JOINT REGIONAL PLANNING PANEL (Sydney East Region)

SUPPLEMENTARY ASSESSMENT REPORT

JRPP No	2016SYE015
DA Number	DA 487/2015
Local Government Area	North Sydney Council
Proposed Development (As Amended)	Demolition of existing residential flat building and construction of mixed use building consisting of 91 apartments, commercial space and 85 car-spaces (Amended proposal)
Street Address	229 & 231 Miller Street, North Sydney
Applicant	Yaver Pty Ltd
Owner	Yaver Pty Ltd
Number of Submissions	Six (6) submissions (Original Proposal) Two (2) to previous amended proposal Two (2) to subject amended proposal
Regional Development Criteria (Schedule 4A of the Act)	Capital Investment Value > \$20 m
List of All Relevant s79C(1)(a) Matters	North Sydney LEP 2013 - Zoning – B4 Mixed Use North Sydney DCP 2013 S94 Contributions SEPP No. 55 – Remediation of Land SEPP No.65 – Design Quality of Residential Flat Development – Apartment Design Guide SEPP (Building Sustainability Index: BASIX) 2004 SREP (2005) – Sydney Harbour Catchment

Figure 12: 3D "Sun's eye" view of the proposed development at 8:30 am to 21 June 2016.

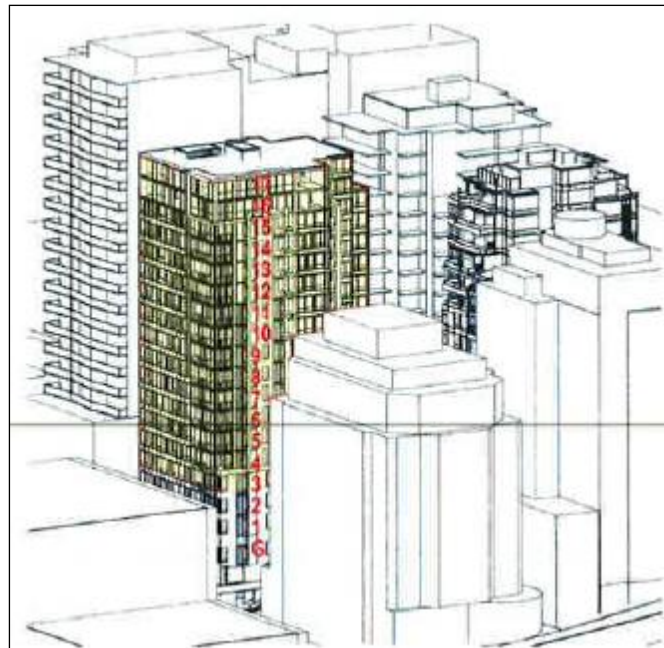
Having regard for the planning principle and the Council's previous supplementary report, it is appropriate that the Panel give consideration to some early morning solar access for unit dwellers at the eastern façade as well as consideration for superior views and outlook from the eastern elevation. The applicant's reliance on performance prior to 8:30am, however should not be accepted.

The Panel may however wish to apply a balanced consideration of total unit amenity for this building, which weighs up the poor solar performance arising from unfavourable site orientation and unit design with the improvements incorporated into the amended scheme. The amended Revision E plans have significantly reduced the number of poorly performing units in the scheme, and the other positive amenity characteristics of the design, such as the greater exposure to views outlook and enclosure of balcony spaces as winter gardens at the building's higher levels, where wind loading would otherwise render these spaces unusable as outdoor open spaces.
